BUTTE REGIONAL TRANSIT OPERATIONS CENTER

Tenant Improvement

ADDENDUM NO. 1

1/4/2016

SIGNAGE PLAN & ROOM
FINISH SCHEDULE

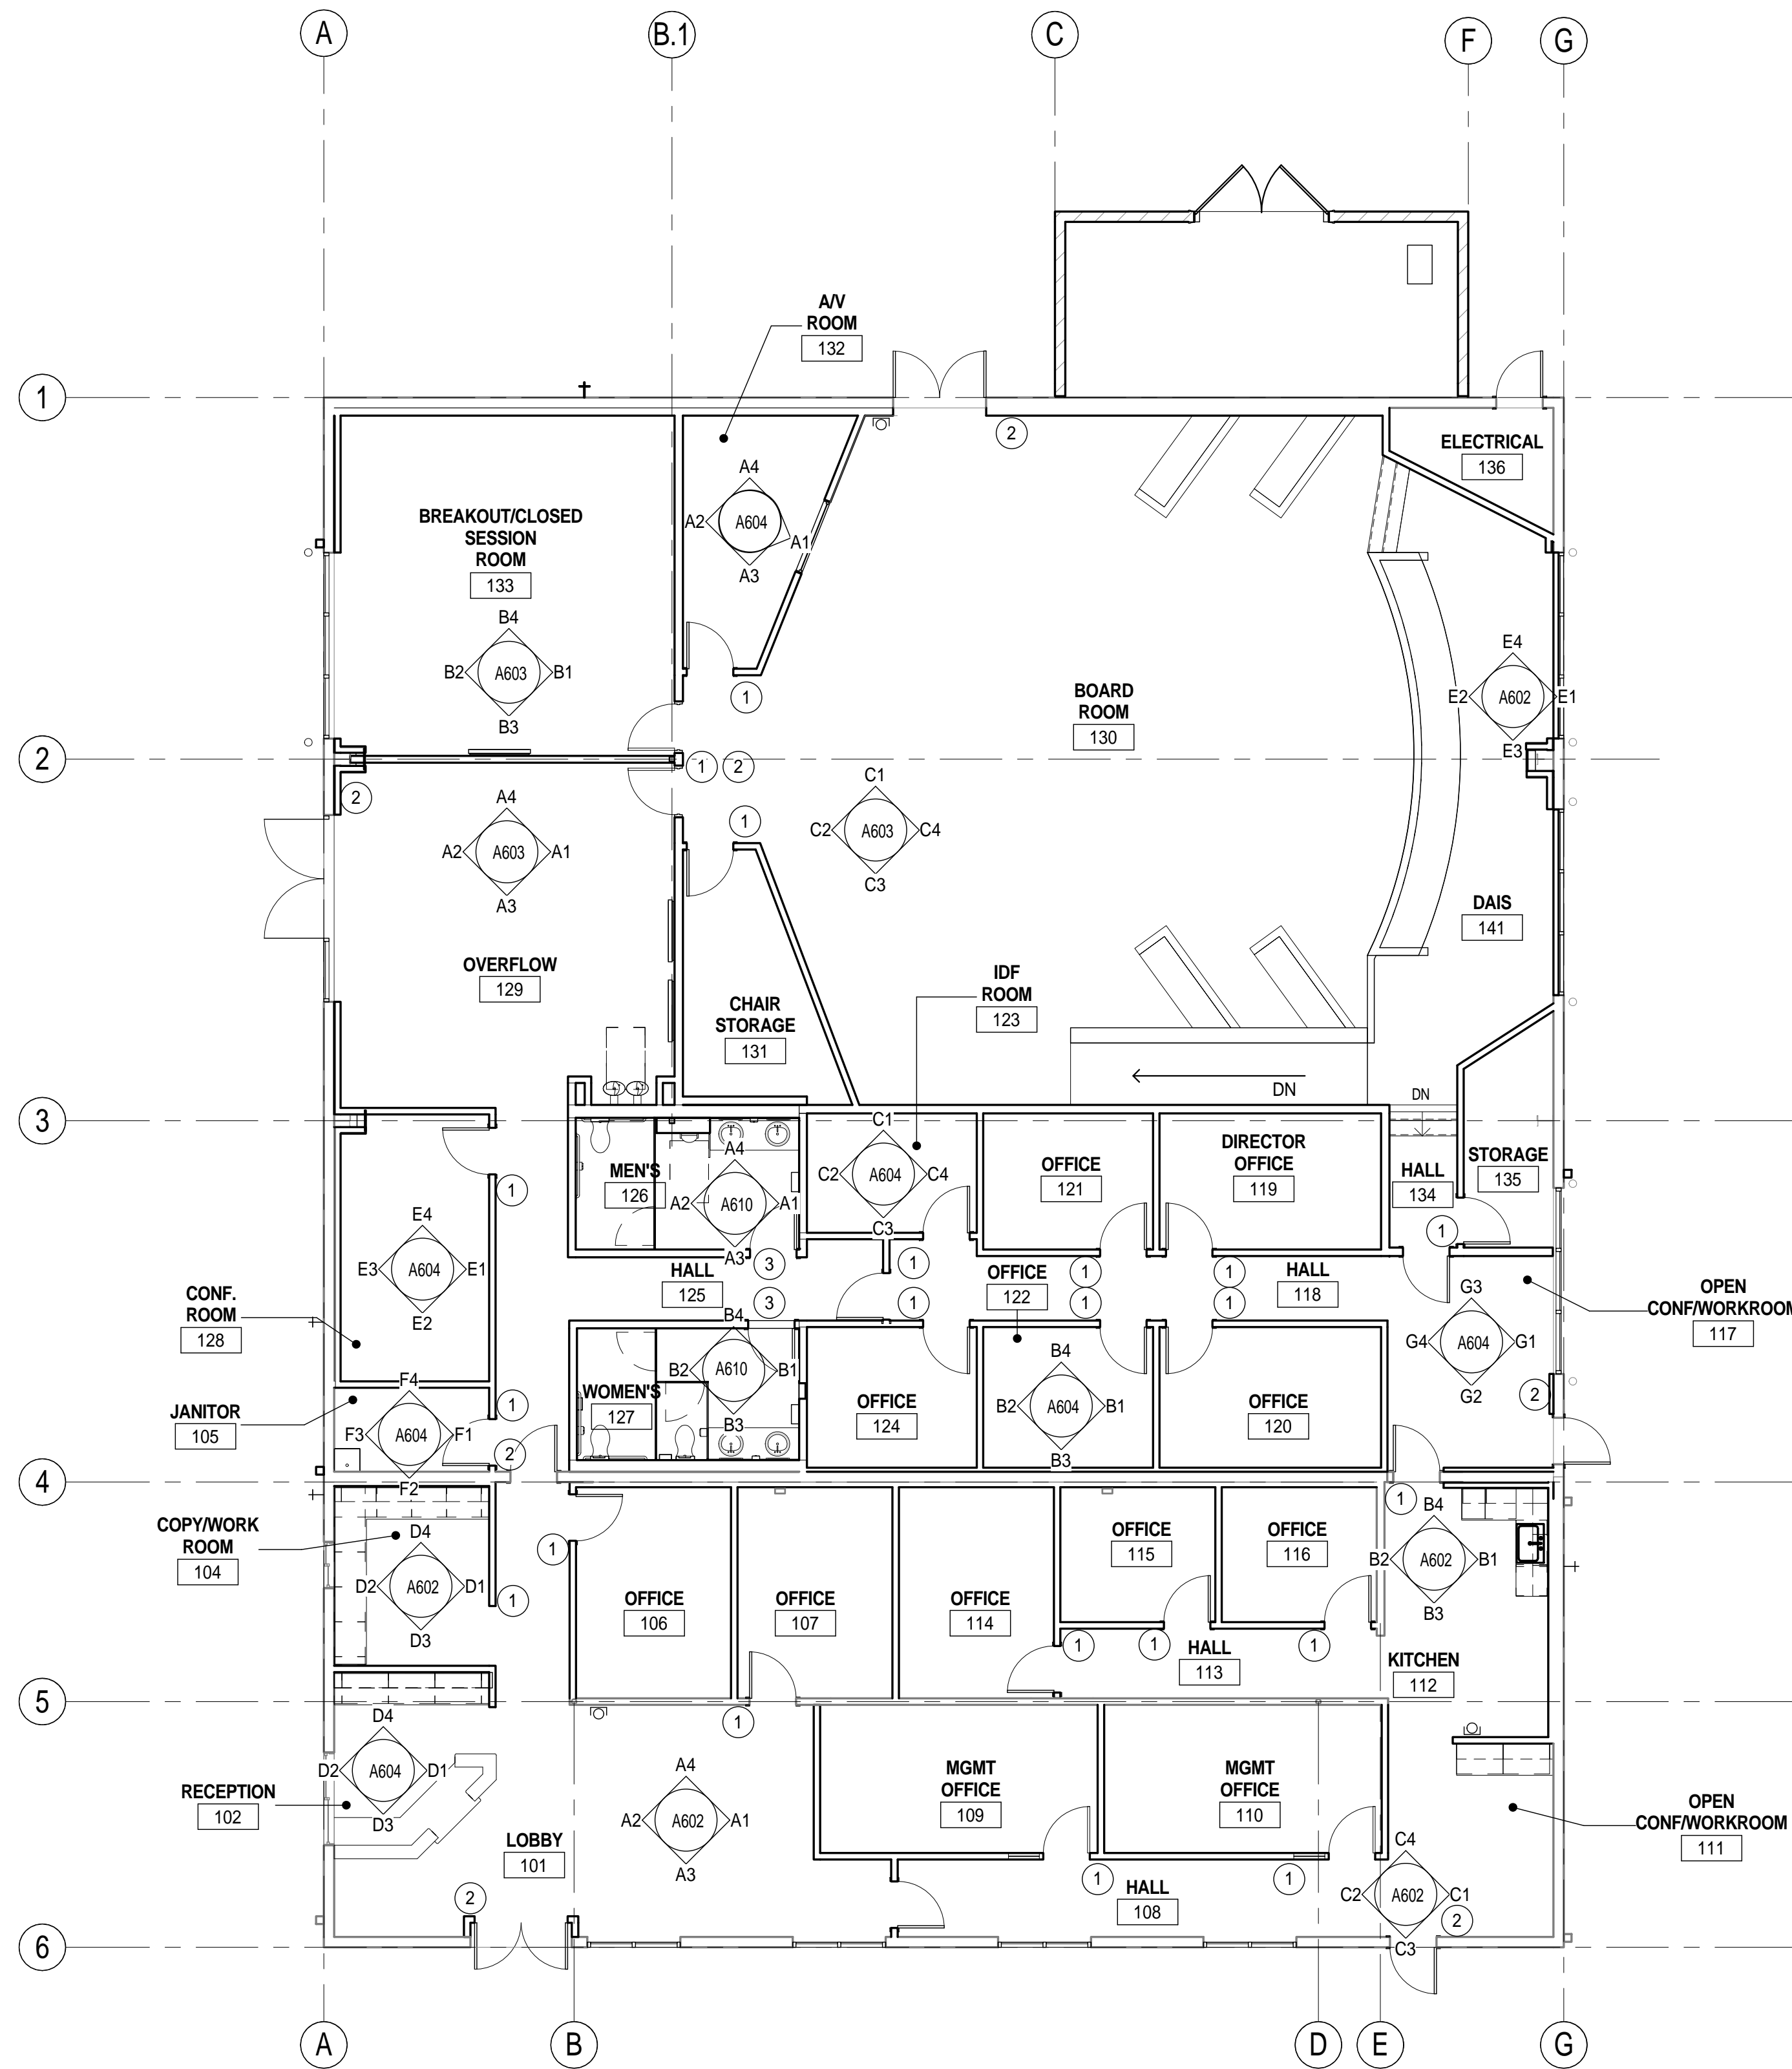
- b. Keynote 14 added
 - c. Detail 4 - West Elevation - Keynote 14 shown at louvered gate
 - d. Finish schedule revised
- 1.7 REVISION TO DRAWING A601 - SIGNAGE PLAN & ROOM FINISH SCHEDULE

- a. Room finish schedule revised as shown
 - b. Material Legend revised as shown
- 1.8 REVISION TO DRAWING A602 - INTERIOR ELEVATIONS
 - a. Elevations E2, C4, D2, D4, B1, B3 & B4 all have clarifications to finishes
